- SITE PLAN AMENDMENT NOTES**
- THE INCLUDED SITE PLAN AMENDMENT INVOLVES ONLY THE MODIFICATION OF THE FOLLOWING ITEMS:
 - REMOVE EXISTING VESTIBULE AT NORTHERN MOST ENTRANCE TO ALLOW FOR THE CREATION OF AN ADDITIONAL ENTRANCE.

DOVER PLAZA
 TOWN OF DOVER, DUTCHESS COUNTY, NY

AMENDED SITE PLAN

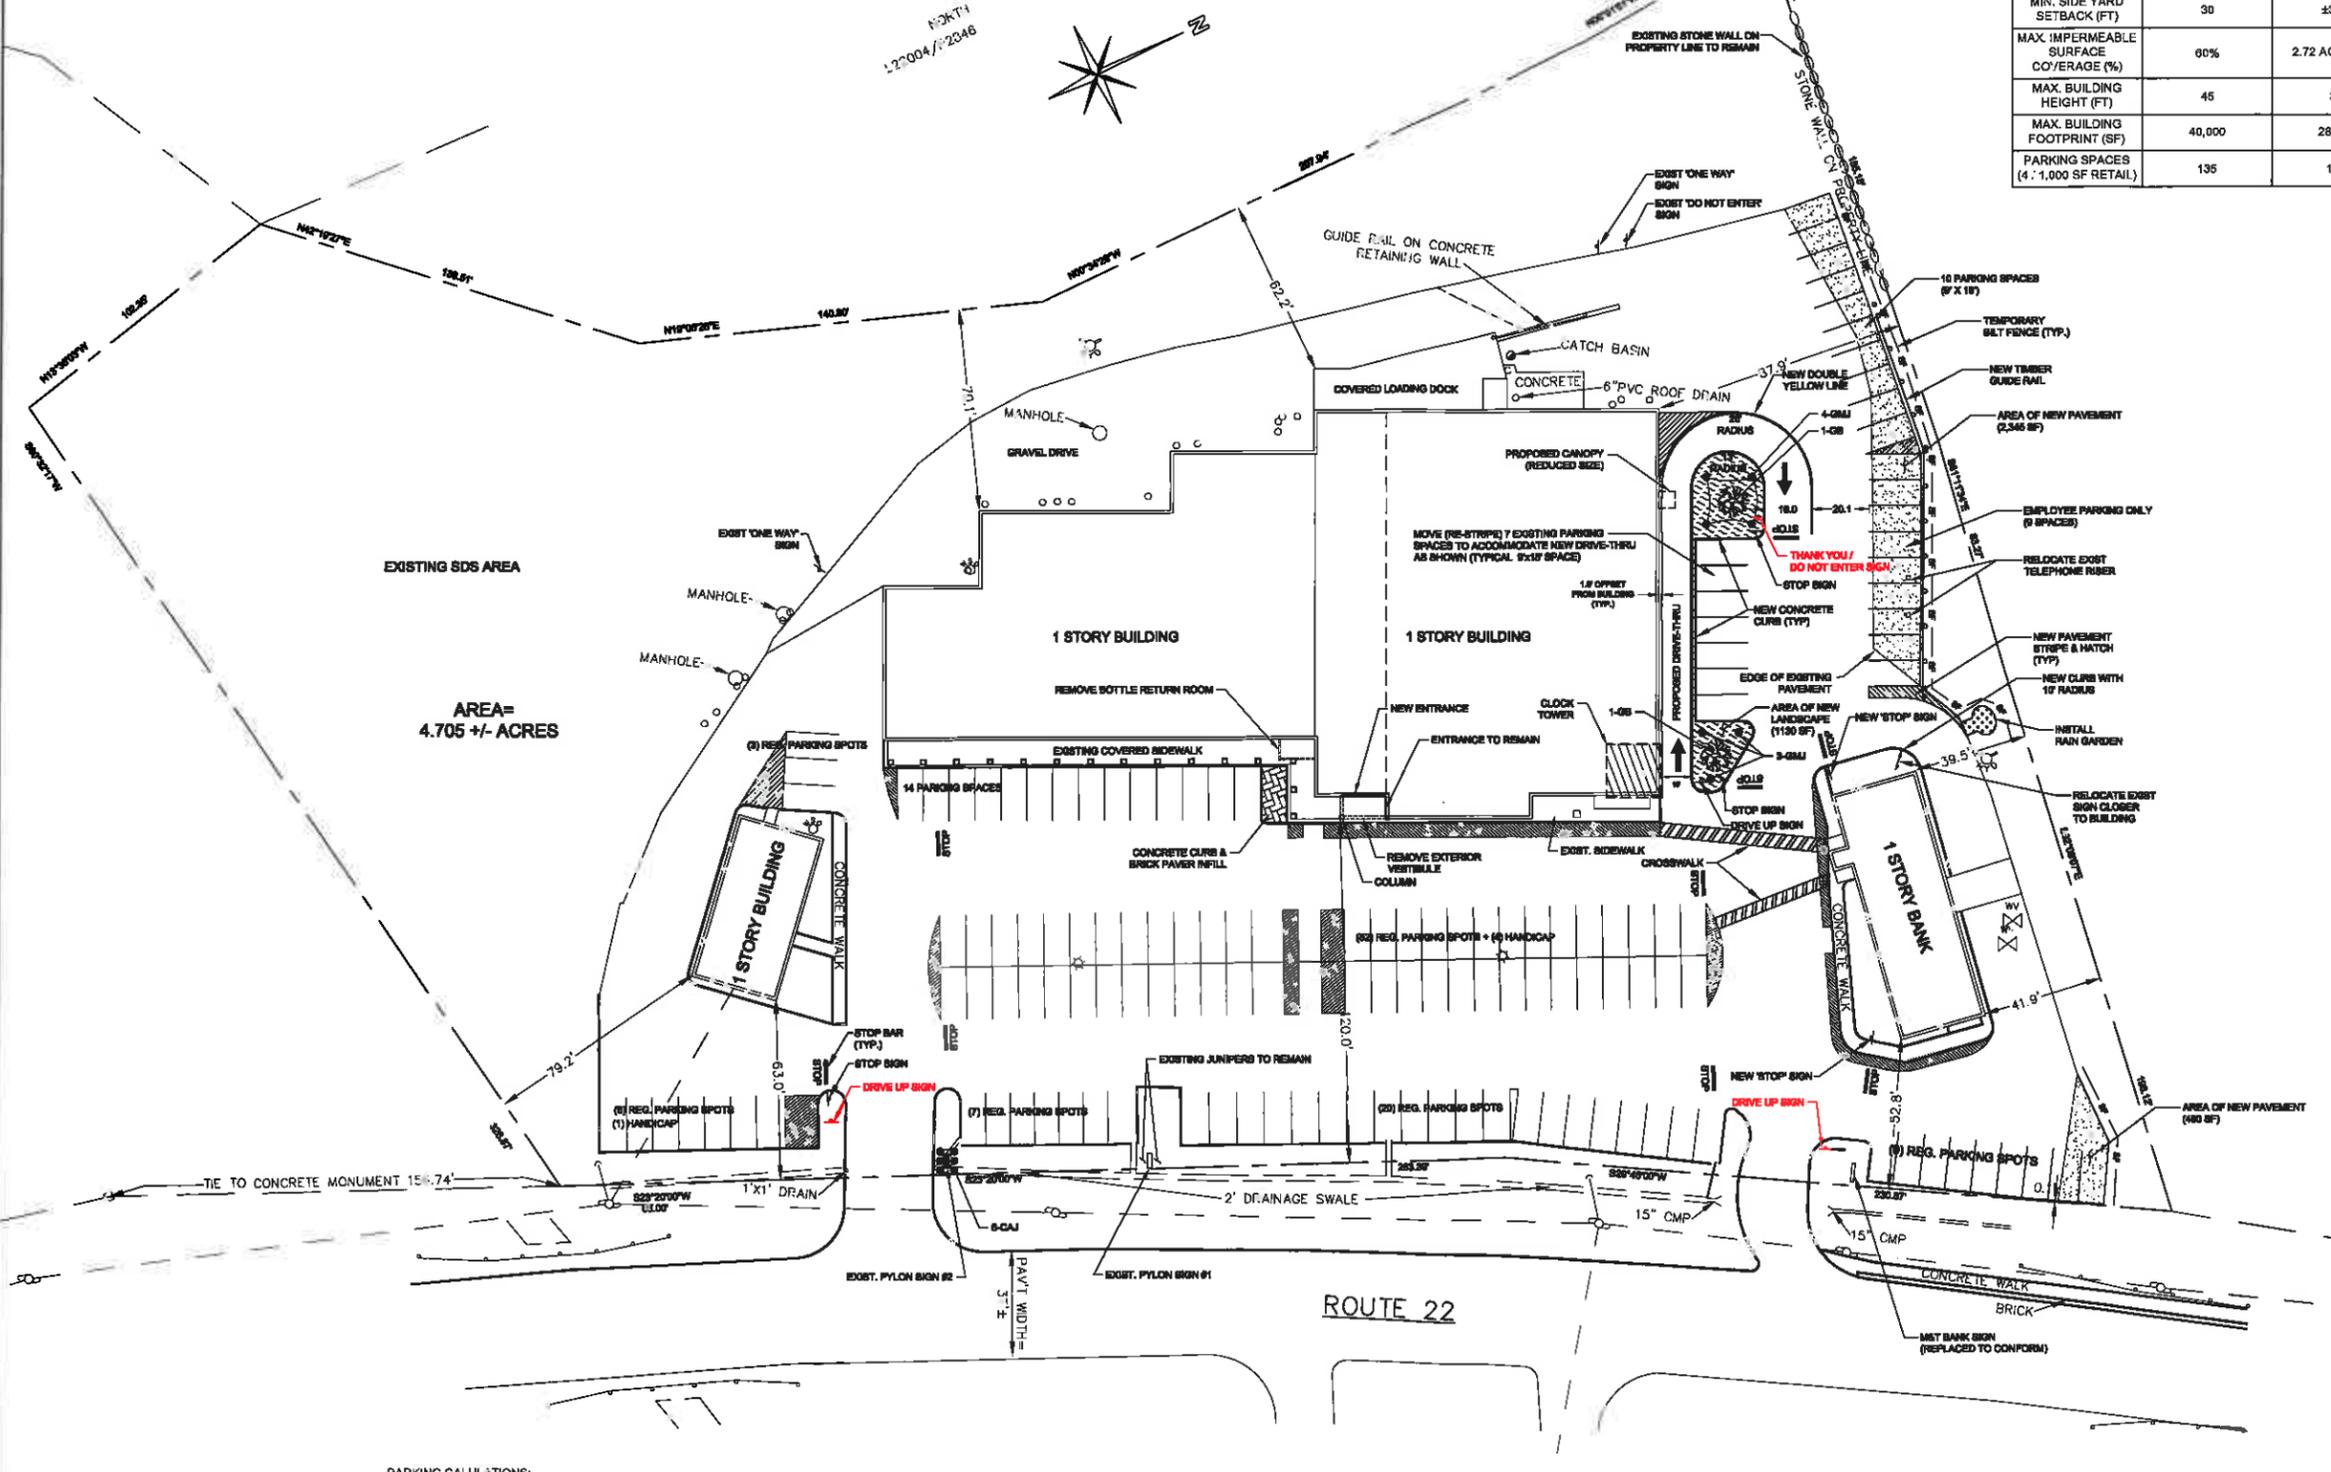
- REMOVE EXISTING EXTERIOR BOTTLE RETURN ROOM TO OPEN UP EXTERIOR WALL SPACE FOR THE CREATION OF AN ADDITIONAL ENTRANCE.
 - REMOVE EXISTING BRICK FROM OLD STOREFRONTS TO ALLOW THE INSTALLATION OF MULTIPLE DOORS AND WINDOWS.

- REDUCE THE SIZE OF THE PREVIOUSLY APPROVED CANOPY OVER THE PICK-UP WINDOW AREA.
 - WITH THE EXCEPTION OF THE ABOVE LISTED MODIFICATIONS, ALL PREVIOUSLY APPROVED SITE PLANS AND CONDITIONS OF APPROVAL ARE TO REMAIN IN EFFECT AND TO BE FULLY ENFORCEABLE BY THE TOWN OF DOVER CODE ENFORCEMENT OFFICER.

DATE	REVISION
8/3/14	ADDED DIRECTIONAL SIGNS
